MADISON LANDING SITE PLAN REVIEW – Review and Recommendation

Date: April 17, 2018
To: Planning Commission
From: Kelly Tayara, Associate Planner
Project: Madison Landing Site Plan and Design Review
File No: PLN 50879 SPR

Request: The Department of Planning and Community Development requests Planning Commission recommendation on application for Site Plan and Design Review permit for Madison Landing, a 24-unit multi-family development.

LANDSCAPE PLAN
MADISON LANDING
BAINBRIDGE, WA

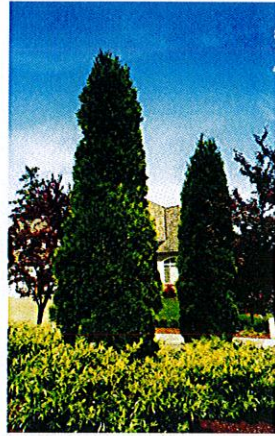
The landscape plan depicts at least 31 evergreen native trees and 54 native evergreen shrubs proposed for planting within the buffer. The plan also depicts proposed groundcover in adequate quantity.

In order to meet the landscape requirements of BIMC 18.15, the following items should be addressed in a revised plan: Modify the plan to reflect developer agreements (e.g. the lot after dedication of rights-of-way); Identify whether each species is native and whether each species is drought-tolerant; Remove the note authorizing substitutions by approval of the landscape architect / owner or add the requirement that substitutions also be authorized by the Department of Planning and Community Development (PCD); Remove the note requiring that all work be performed to the satisfaction of the landscape architect / owner or add the requirement that the work also be performed to the satisfaction of PCD; Eliminate the note stating that plant list quantities are shown for reference only; Remove the note that states that groundcover quantities shall be adjusted as required for field conditions at the specified spacing.

Subsequent to right-of-way dedication, the site is 1.87 acres in size. The total tree unit requirement is 75 tree units (1.87×40) . The applicant elects to plant trees to meet this requirement. The submitted landscape plan depicts trees in future right-of-way and the plan should be modified to meet tree unit requirements on site (i.e. either provide additional trees or relocate the trees depicted in the south 15 feet of the property).

5. A landscape plan which meets the requirements of BIMC 18.15 shall be required with building permit submittal. The revised landscape plan shall address the following:

- a. The plan shall be modified to reflect developer agreements (e.g. relocating trees outside of the future Wallace Way right-of-way)
 - b. The plan shall identify whether each species is native and whether each species is drought-tolerant.

- c. The plan shall be amended to remove the note authorizing substitutions by approval of the landscape architect / owner or add the requirement that substitutions also be authorized by the Department of Planning and Community Development.

- d. The plan shall be amended to remove the note requiring that all work be performed to the satisfaction of the landscape architect / owner or add the requirement that the work also be performed to the satisfaction of the Department of Planning and Community Development.

- e. The plan shall be amended to remove the note stating that plant list quantities are shown for reference only.
 - f. The plan shall be amended to remove the note that states that groundcover quantities shall be adjusted as required for field conditions at the specified spacing; groundcover shall be planted and spaced to achieve total coverage within five years, and the landscape plan must demonstrate this requirement.
